Project	<b>IEEE 802.16 Broadband Wireless Access Working Group</b> < <a href="http://ieee802.org/16">http://ieee802.org/16</a> >	
Title	<b>Complementary document for draft comments</b>	
Date Submitted	<b>2004-01-07</b>	
Source(s)	Yossi Segal Itzik Kitroser Yigal Leiba Zion Hadad Runcom Technologies Ltd. 2 Hachoma St. 75655 Rishon Lezion, Israel	Voice: +972-3-9528440 Fax: +972-3-9528805 <a href="mailto:yossis@runcom.co.il">yossis@runcom.co.il</a> <a href="mailto:itzikk@runcom.co.il">itzikk@runcom.co.il</a> <a href="mailto:yigall@runcom.co.il">yigall@runcom.co.il</a> <a href="mailto:zionh@runcom.co.il">zionh@runcom.co.il</a>
Re:	Contribution elaborating on comments for letter ballot #13a	
Abstract	This document includes text referenced in several comments given for ballot 13a	
Purpose	To be integrated into P80216-REVd_D2 document	
Notice	This document has been prepared to assist IEEE 802.16. It is offered as a basis for discussion and is not binding on the contributing individual(s) or organization(s). The material in this document is subject to change in form and content after further study. The contributor(s) reserve(s) the right to add, amend or withdraw material contained herein.

**Figure 214—DL Frame Prefix sub-channel allocation for segment 1 using FUSC**

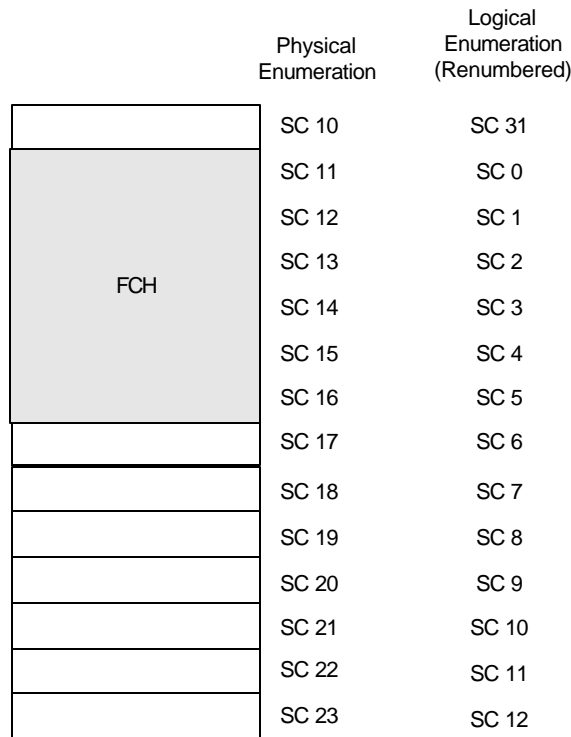
In FUSC, the first ~~642~~ transmitted subchannels in the first data symbol of the downlink contains the FCH as defined in 8.4.4.2 (using QPSK rate 1/2 and repetition coding of ~~64~~), for any segment the first 6 sub-channels of the segment shall ~~Subchannels 0-11~~ contain the FCH. Figure 214 depicts this structure:

Figure 230a— Example of using FHDC in OFDMA

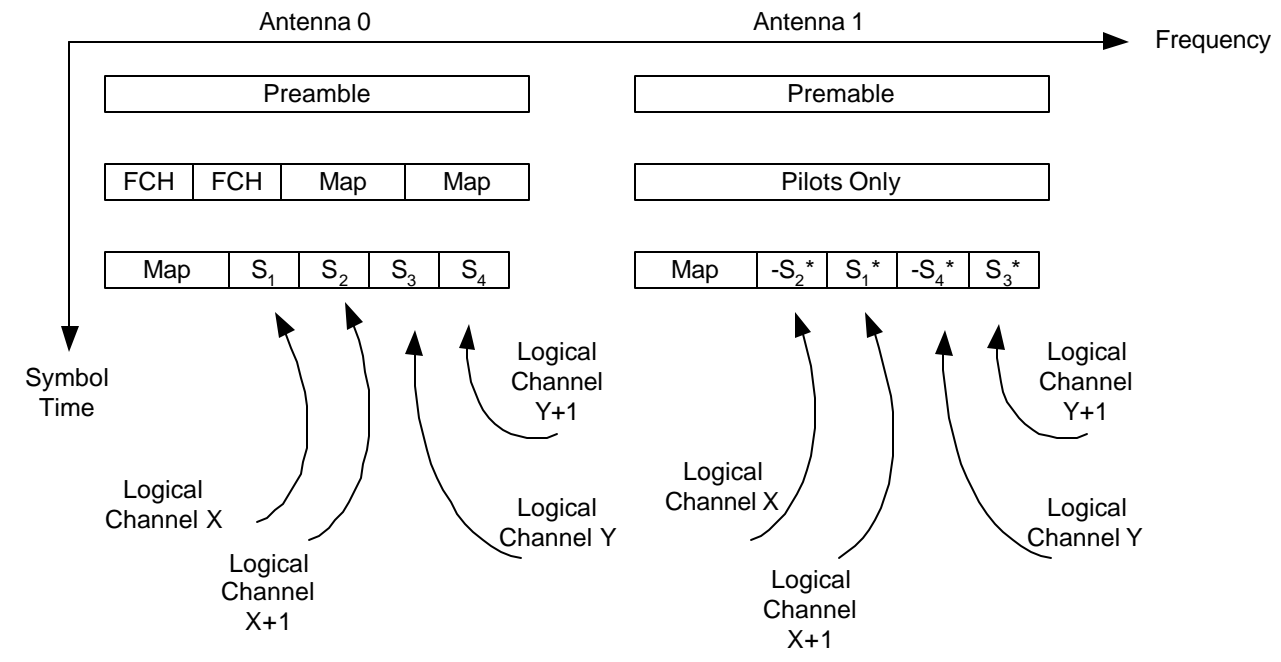
The downlink shall enable the co-transmission of regular Subchannel transmission and FHDC Subchannel transmission as explained in 8.4.8. The minimal allocation of subchannels for a segment (if the segment is used) is 5 subchannels (and shall follow section 8.4.4.5), when FHDC is used then the encoding of the DL-MAP shall also be performed using the same repetition rate as the FCH (this is done to enable the adequate reception of the FCH and the DL-MAP by Transmit diversity users, as well as regular users). The DL-MAP shall define the combined FHDC and regular transmission allocations, regular allocations shall be transmitted from antenna 0 only, while STC allocations shall be transmitted from both antennas (in any case antenna 1 shall always transmit in this combined mode of operation at least the pilot-sets allocated for it) Figure 230a shows an example of FHDC usage for OFDMA.

Figure 230b— Illustration of Transmit diversity using 4 antennas

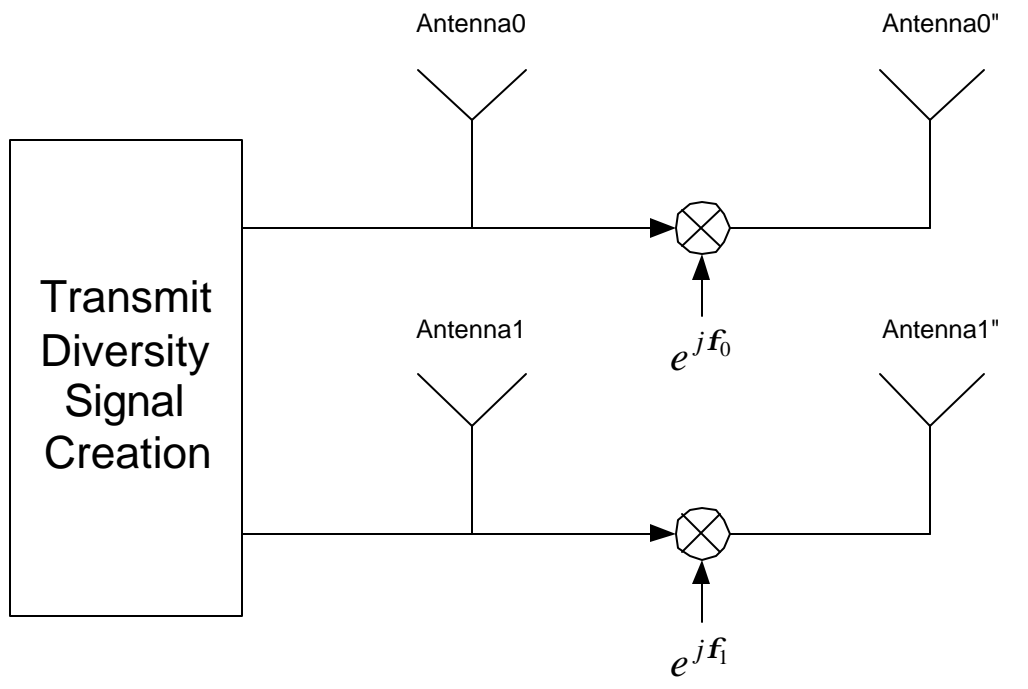
The Transmit diversity schemes could be further enhanced by using 4 antennas at the transmission site. Two antennas are now being used in order to transmit each symbol (the first antenna transmits the signal as defined in 8.4.8.2 and 8.4.8.3, and the second transmits the same signal with a complex vector rotation), this transmission shall create additional multipaths received by the user, these multipaths aim are to reduce the effect of the Rayleigh channel variation. This method gives the space diversity associated with the STC/FHDC with an additional multipath creation caused by another antenna; this scheme is presented in figure 230b:

This method does not change the channel estimation process of the user, therefore this scheme could be implemented without any changes made to the Transmit diversity user.
